# **SCOPING OPINION:**

## **Proposed Botley West Solar Farm**

**Case Reference: EN010145**

**24 July 2023**

Figure 1  
 showing 'Botley West' in dark blue, the most likely alternate location of the 440kV National Grid substation in light blue, and the perimeter of the proposed Red House Farm solar power station in red

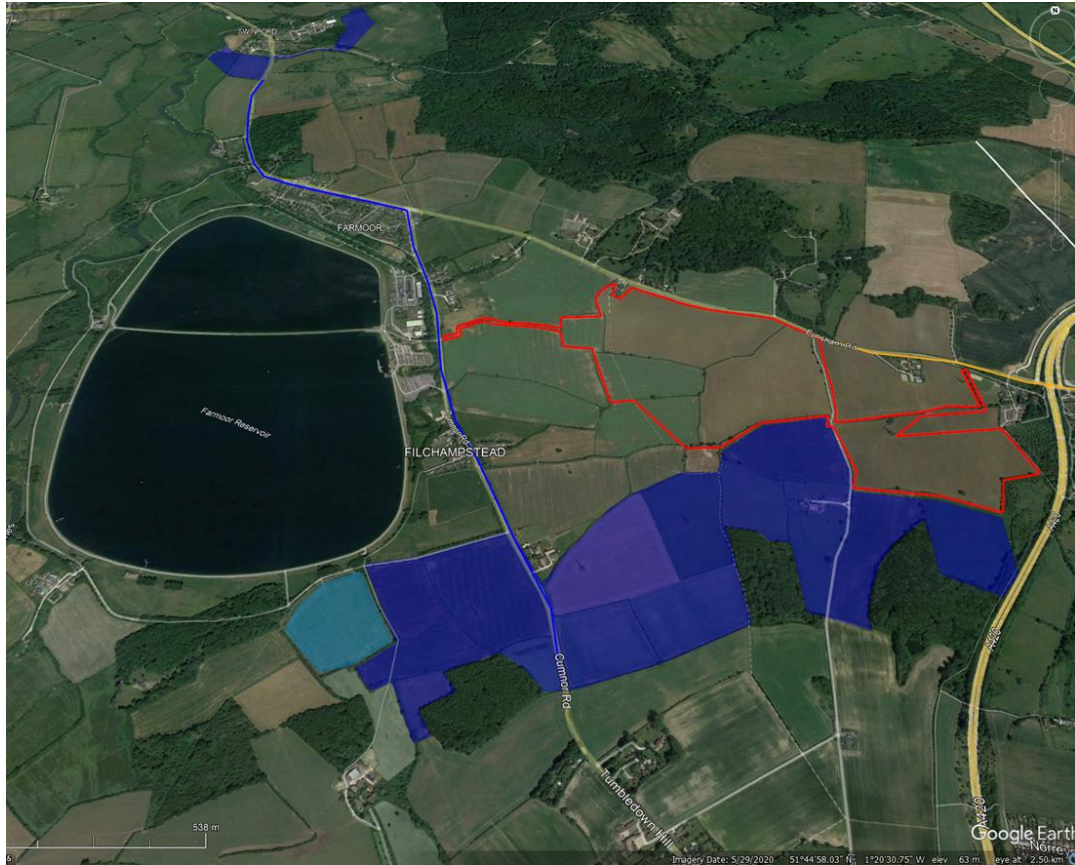
Council draws PINS attention to the fact that the proposed southern site lies immediately adjacent to, and south of, another proposed solar power station (Red House Farm – see Figure 1 below) where the Vale of White Horse District Council (VWHDC) has required an extensive set of Environmental Impact Assessments be carried out ( [P22/V2581/SCO](#) ).

Figure 2

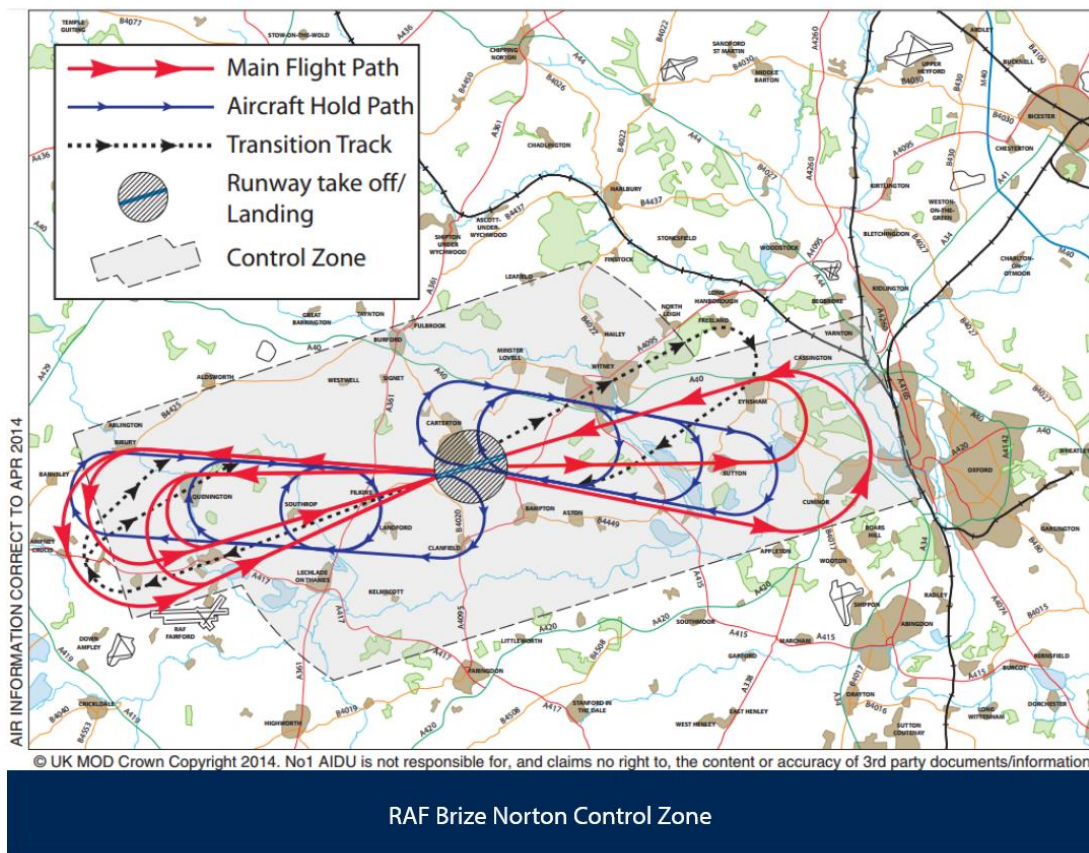
Council requests that RAF Brize Norton (to the west of the central and southern sections, with the southern section being on the designated flightpath) should be included (para 8.3.14) – see also Figure 2 below.

Recent, well publicised fires in solar power stations in the UK and overseas point to the necessity of applying the precautionary principle here, particularly as the site is just a km or so to the west of Oxford and will be within 60m of Thames Water's Farmoor reservoir (14 million litres, supplying Swindon etc.), and which lies directly under the RAF's flight path, and within the Control Zone, for RAF Brize Norton (see [Figure 2](#) below).
